## REMANDED ADMINISTRATIVE HEARING

### MEMORANDUM

**PROJECT:** The Summit on College Parking Structure FDP #130056

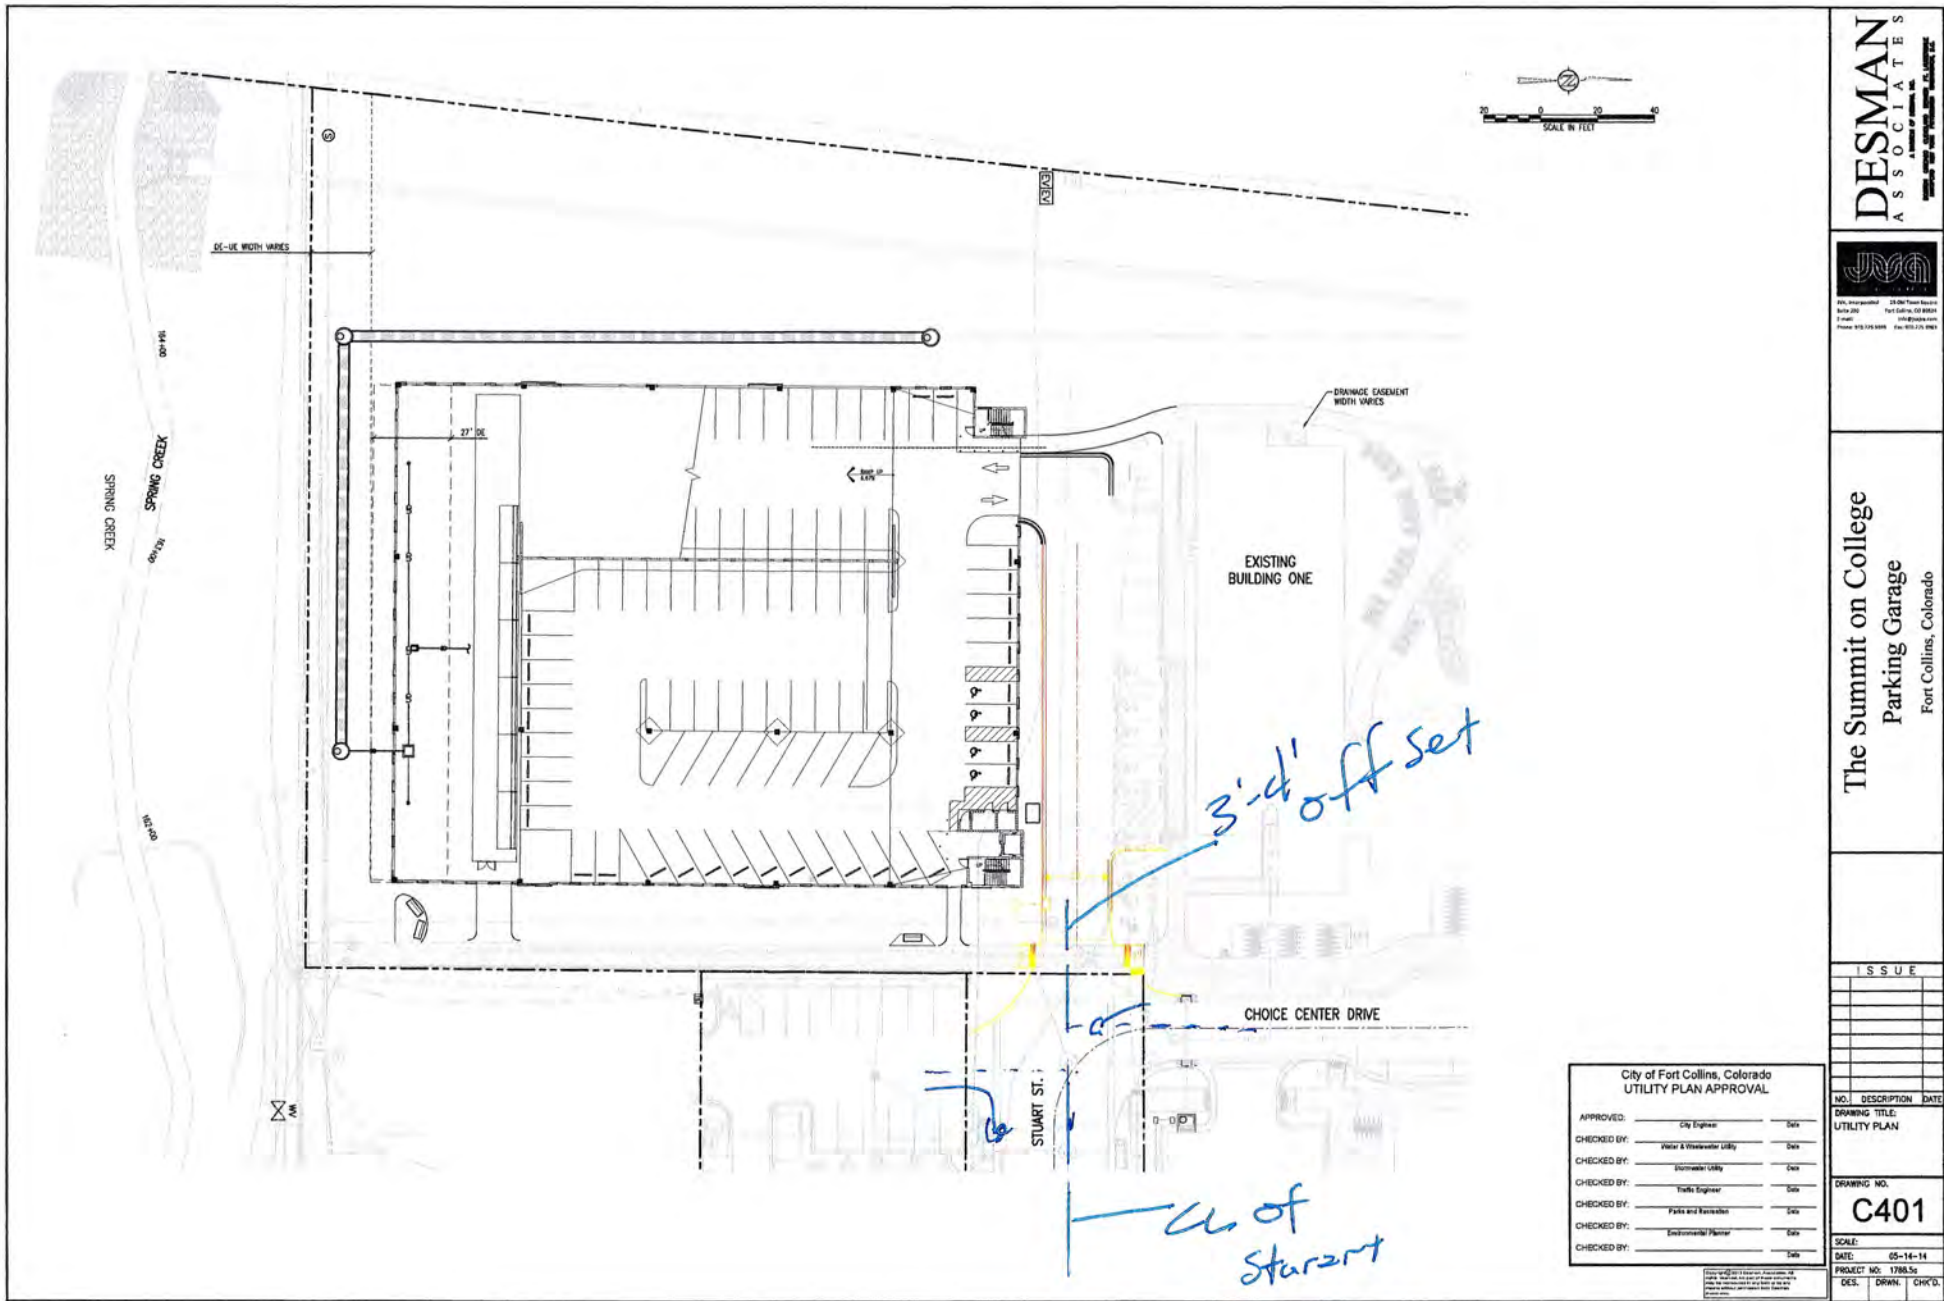
The plans I review did not indicate the type of control that would be used to control the right-of-way at the intersection. The poor alignment shown would be best controlled through a mini-roundabout. That being said, there doesn't appear to be enough space to accommodate a mini roundabout at this location in the built environment.

The 8' alignment still has the same issues as the 17' alternative as it relates to north-south movements. The east-west movements are still not aligned by there appears to be a 3-4 offset. At slow speeds of 20 mph, this alignment will work, but it is far from ideal and should be well lighted to promote safety.

The 8' option has the benefit of preserving premium parking spaces. Additional pavement markings should be used to redirect traffic from on-coming vehicles. An all-way stop is the most appropriate control of the intersection.

SUMMIT SOUTH ELEVATION  
COMPARISON EXHIBIT

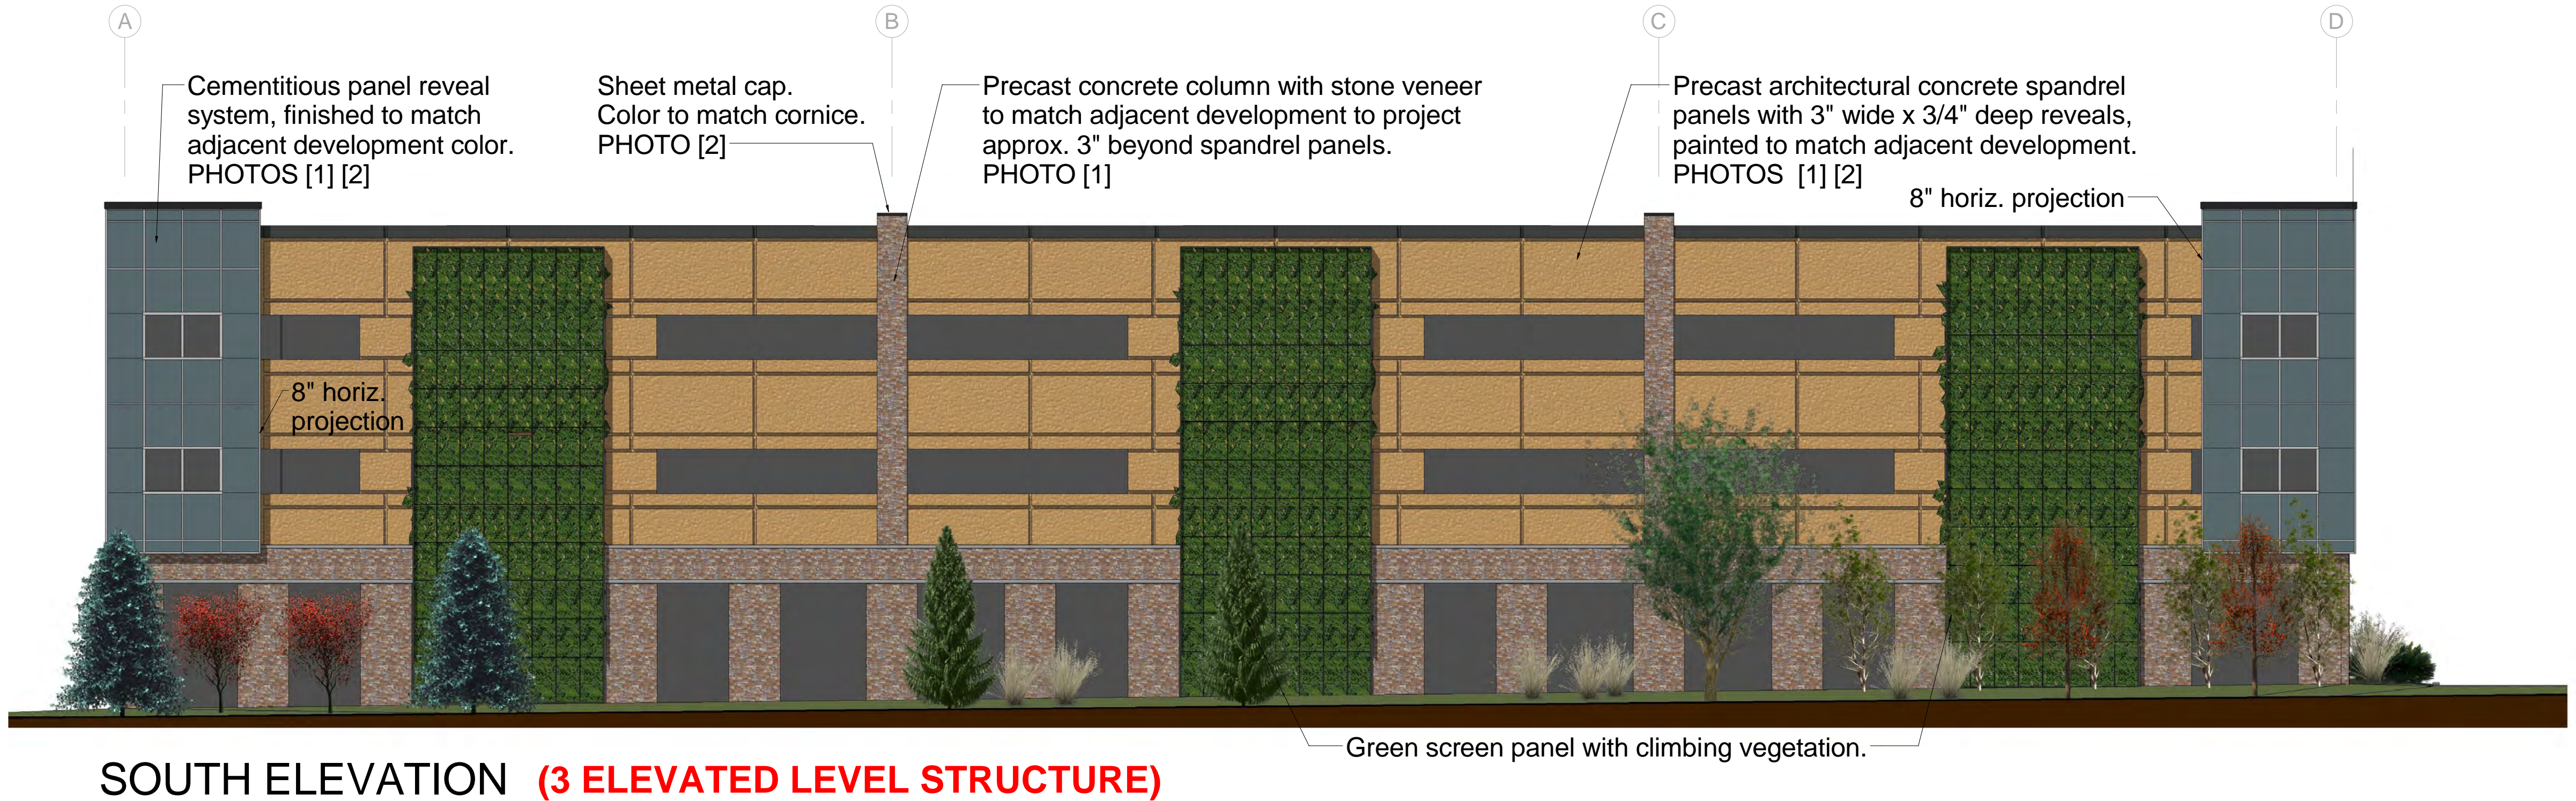
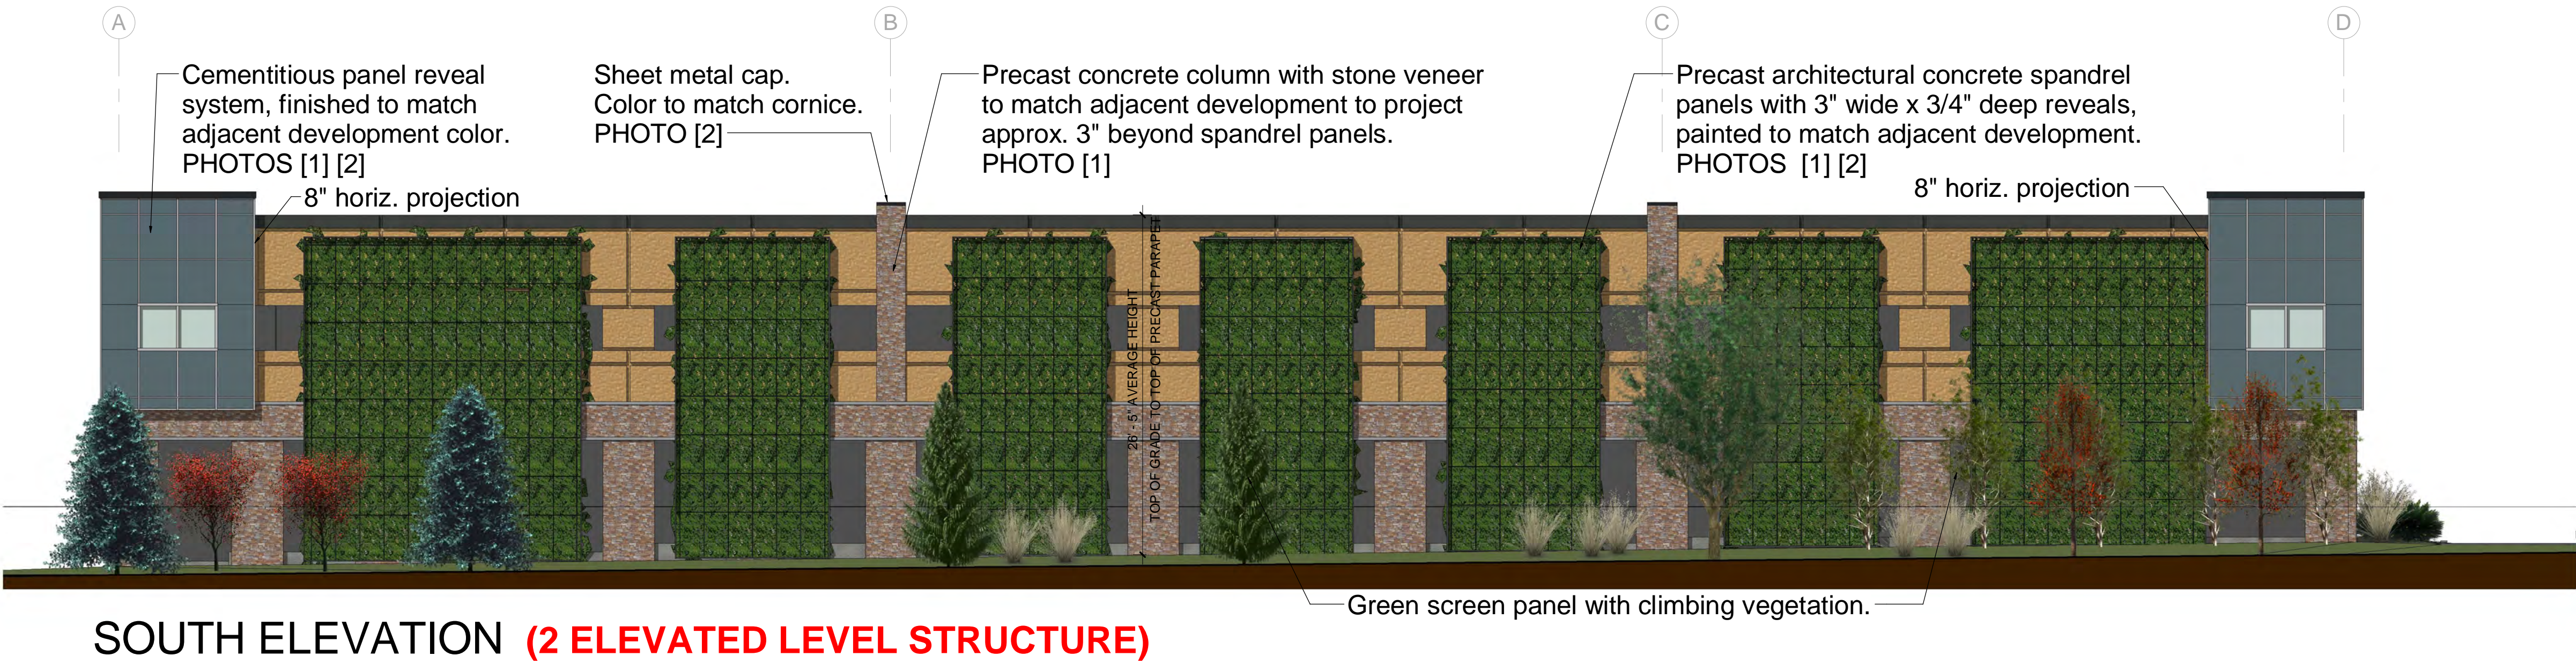
The amended proposal minimizes the obstruction of any scenic views from Spring Creek by reducing the mass of the parking garage from 3 1/2 to 2 1/2 stories along the south elevation. In addition to reducing the mass of the parking garage, the applicants have provided additional vegetative screening along the south wall to soften the appearance of the garage. As with the original proposal, the project proposes to install a multi-structured vegetation buffer that includes 104 trees and shrubs and a native grass seed mix. Finally, the applicant will provide a fee-in-lieu payment to the City of Fort Collins to enhance the planned restoration of Spring Creek, anticipated within the next two years. Renderings have been provided to compare the existing viewshed to the proposed viewshed from Spring Creek (see Attachment 1).
